PORTLAND BUREAU OF TRANSPORTATION

CITY ENGINEER'S REPORT TO CITY COUNCIL FOR AN ABOVE-GRADE ENCROACHMENT PROVIDENCE PARK EXPANSION

Approval is requested of City Council for an Encroachment in the Public Right-of-Way for an Arcaded Structure over the SW 18th Ave Sidewalk

ENLARGED SECTION: ARCADE / CONCOURSE EXIT

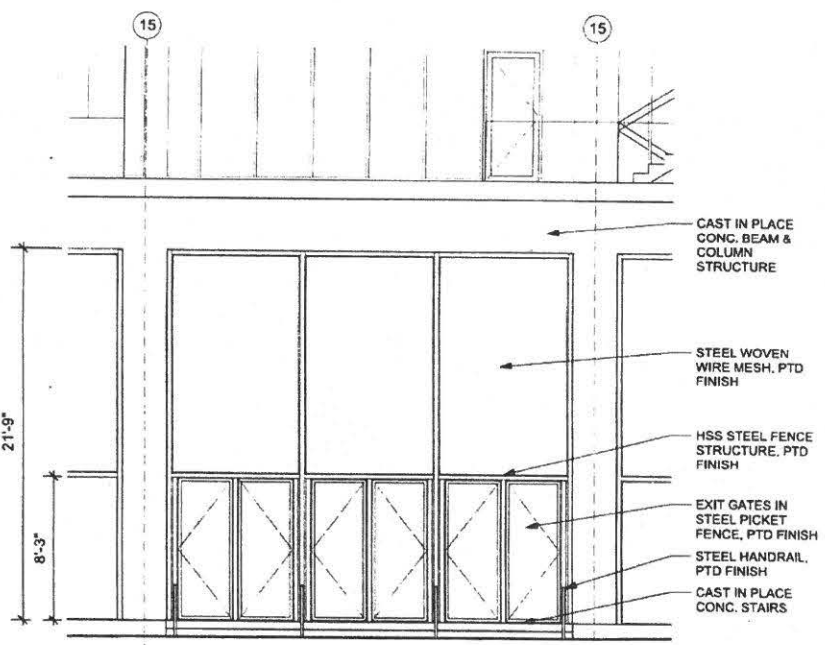
- D. Perimeter fencing along the SW 18th Avenue frontage shall reduce the number of pickets by 50% and use only 2"x2" steel mesh screening.
- E. A minimum height of 11'-3" must be maintained from the SW 18th Avenue sidewalk grade to the bottom of the first elevated level seating structure for the full width of the three middle-bay stadium view corridors from SW 18th Avenue.
